A G E N D A

Architectural Review Board

September 22, 2020 – 5:30 p.m.

1A

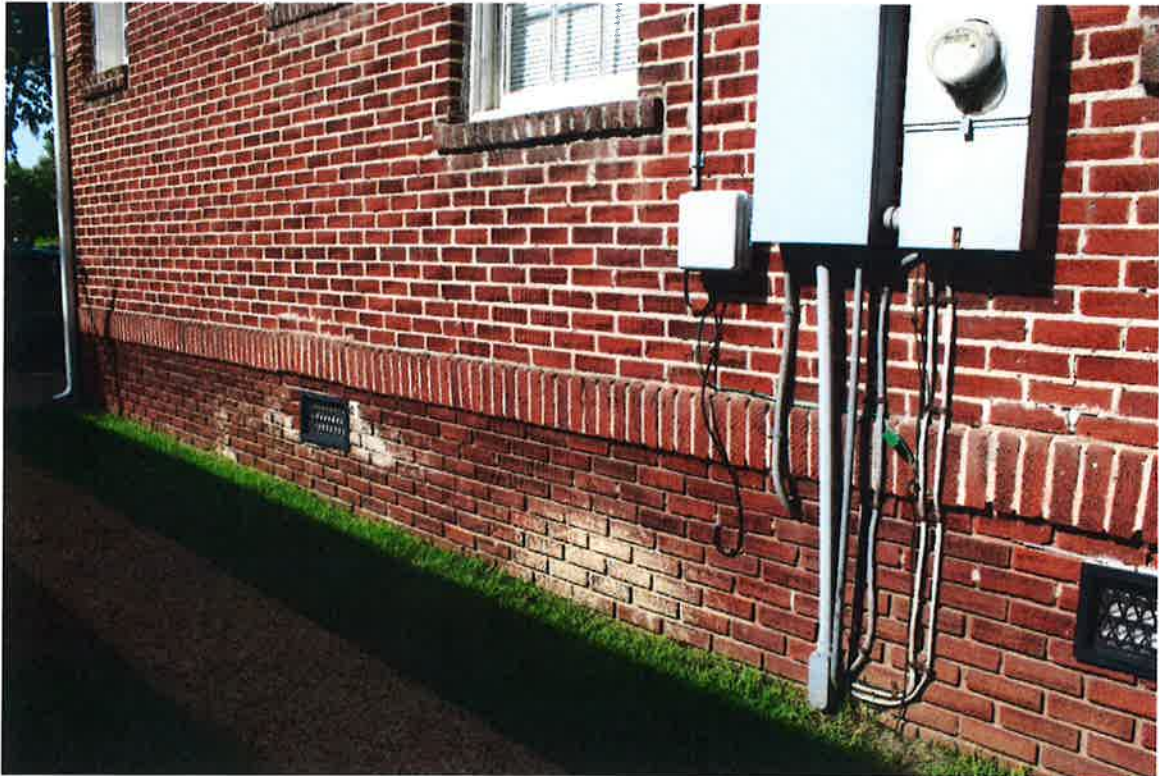
- Tudor Revival houses were intended to be unpainted as they were emulating English Tudor architecture. The house at 1826 S Hull is painted brick, but two stories in a completely different style of architecture.
- The Board has approved painting unpainted brick in instances where there have been poor repairs, mismatched brick, or the brick veneer has had to be removed and reapplied **and** visually becomes distracting through a lack of uniformity. At this juncture, this property does not exhibit those characteristics.

7A

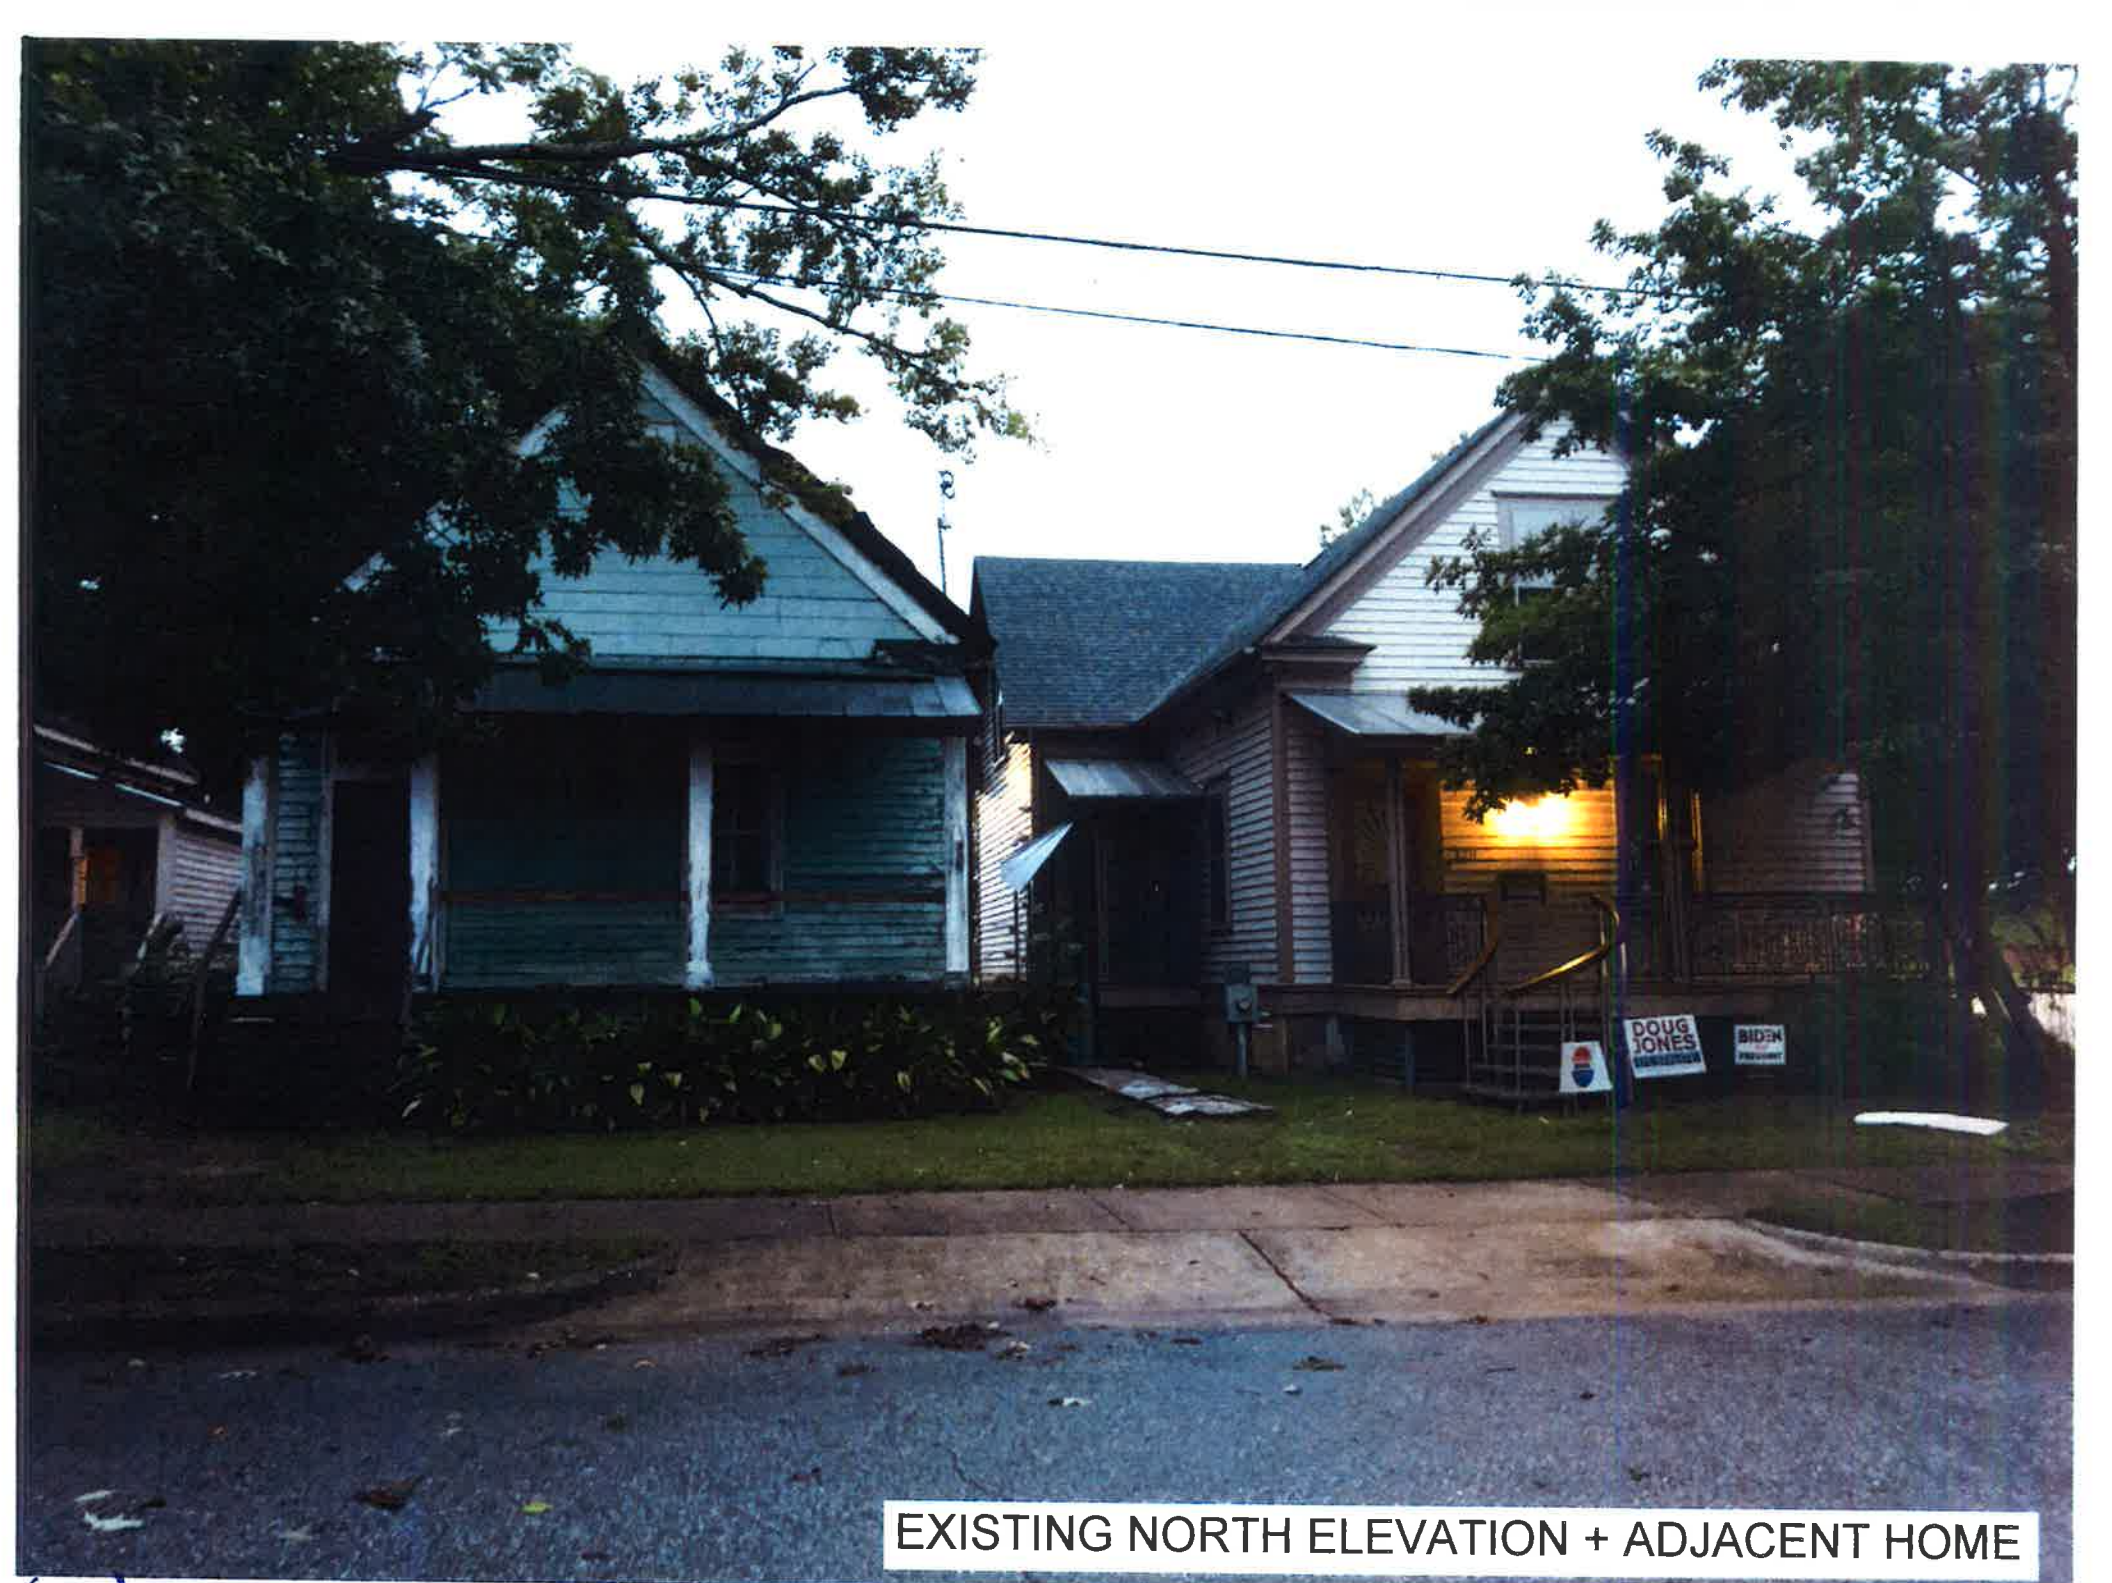
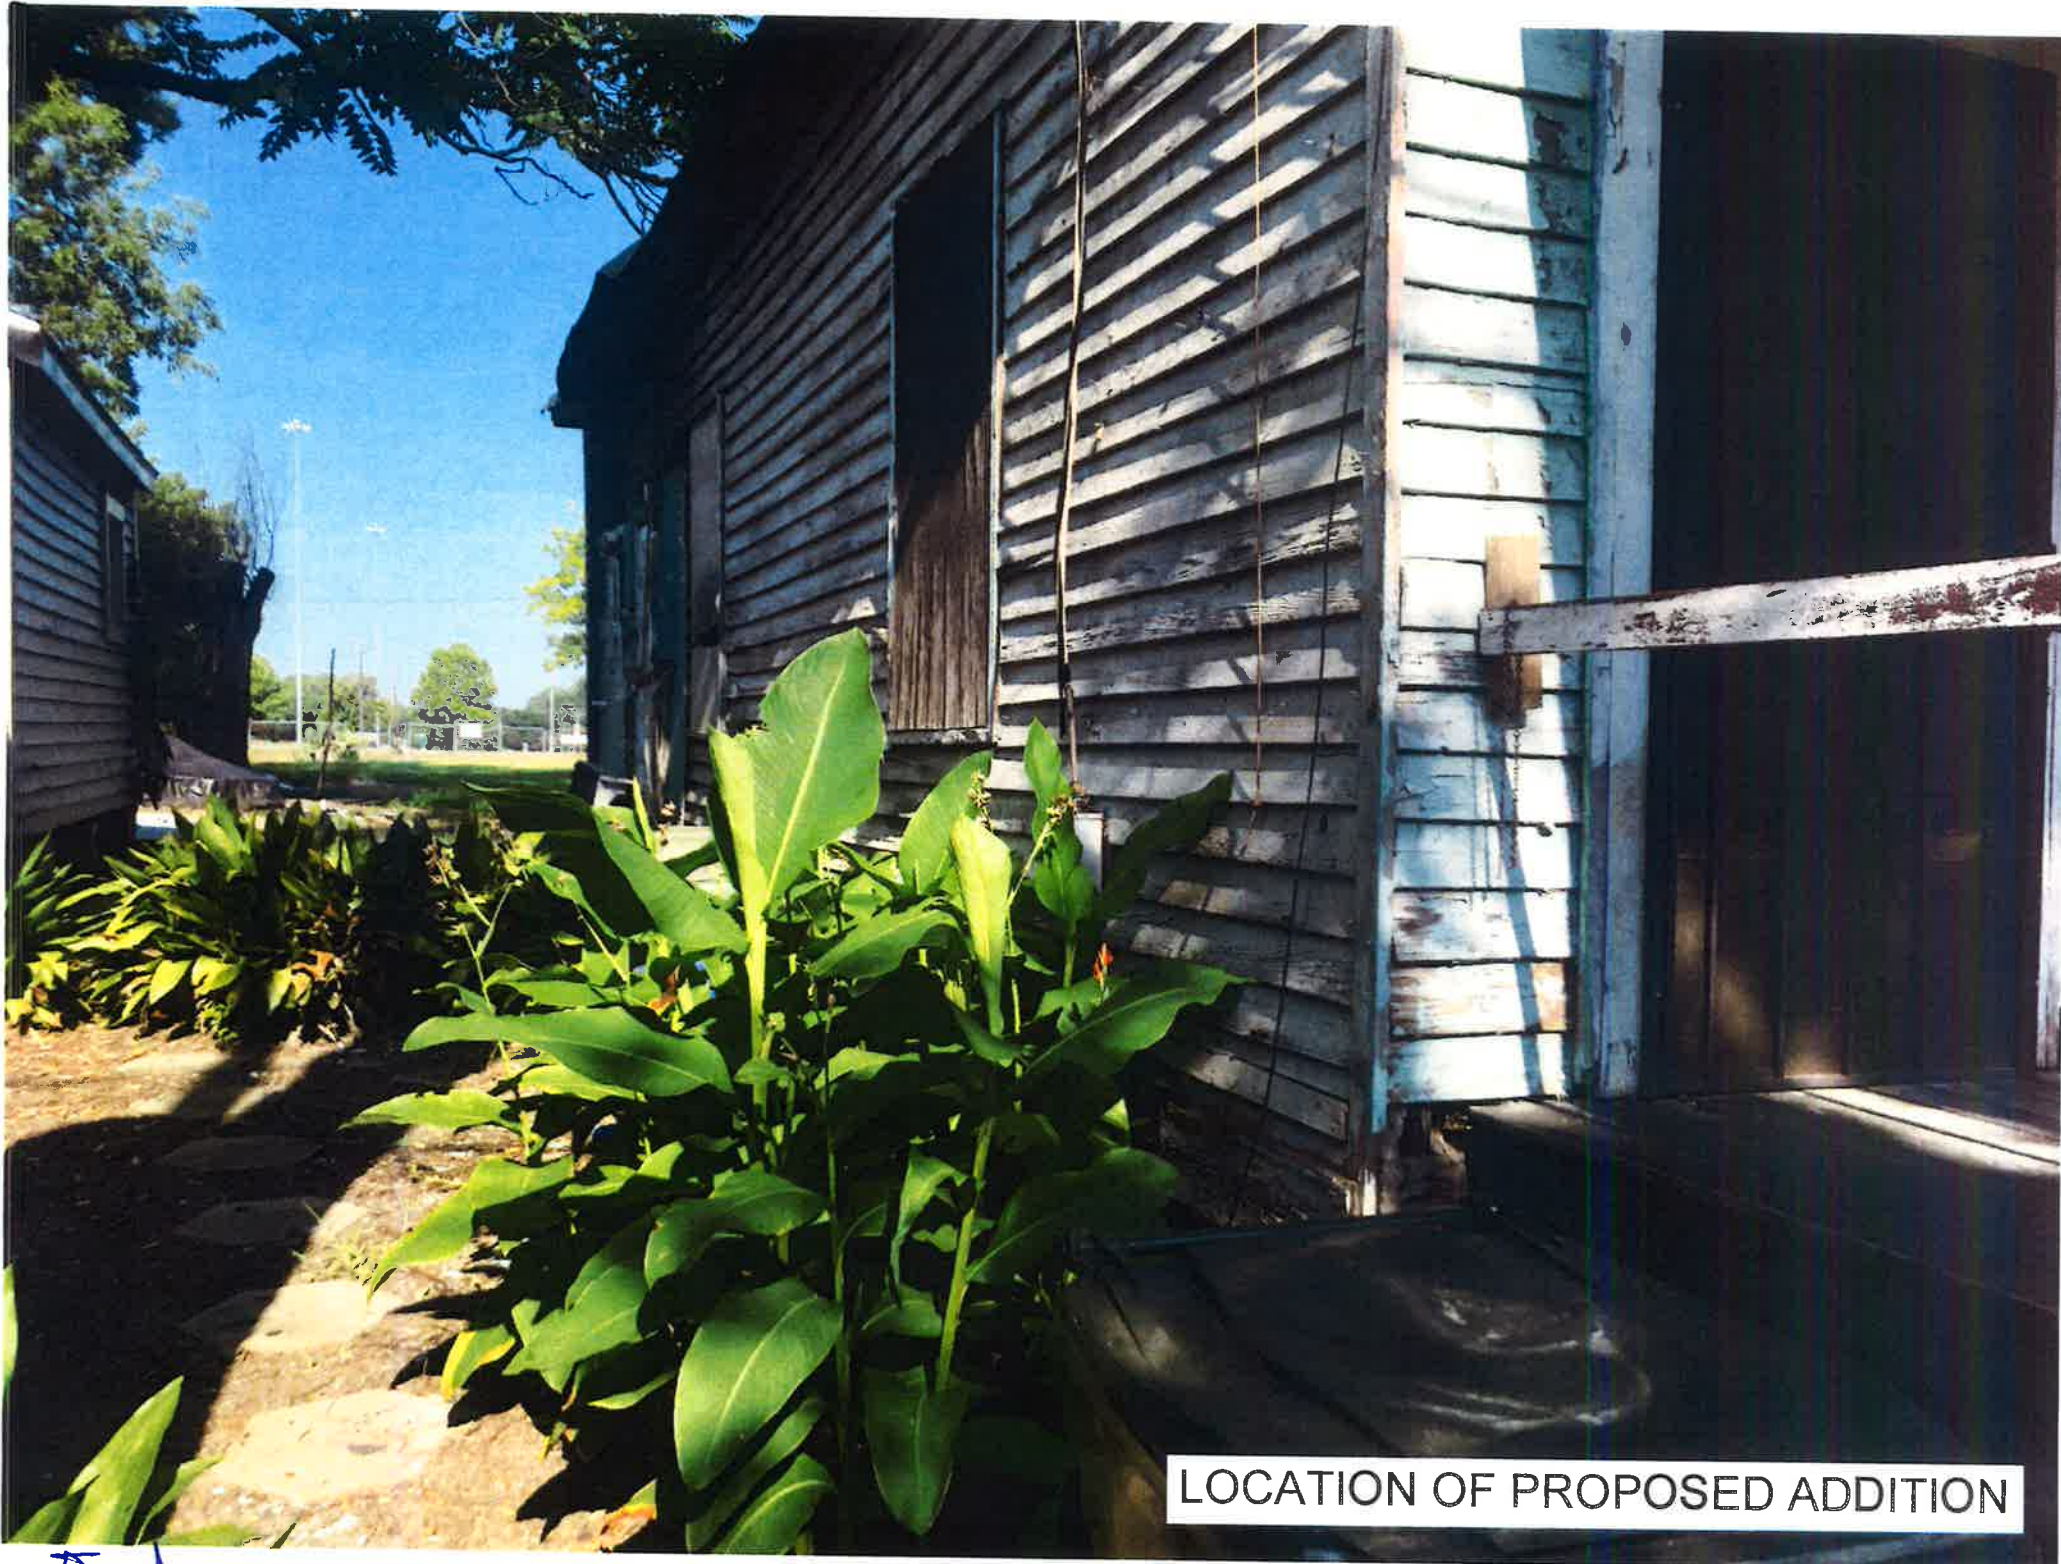
- The Board approved a similar petition (including the tree removal without replacement due to lack of space) in January 2020 for the previous owner.
- The Board has approved the use of cementitious siding on additions, it does help differentiate the original structure from the addition as recommended by the Secretary of the Interior's Standards.
- The Board has approved metal roofs in traditional crimps (e.g. 5-v) on porch roofs and slopes where only a rolled roofing material could be used.
- Aluminum clad simulated divided lite windows have been approved as replacements as they maintain a permanent grid on the glass.
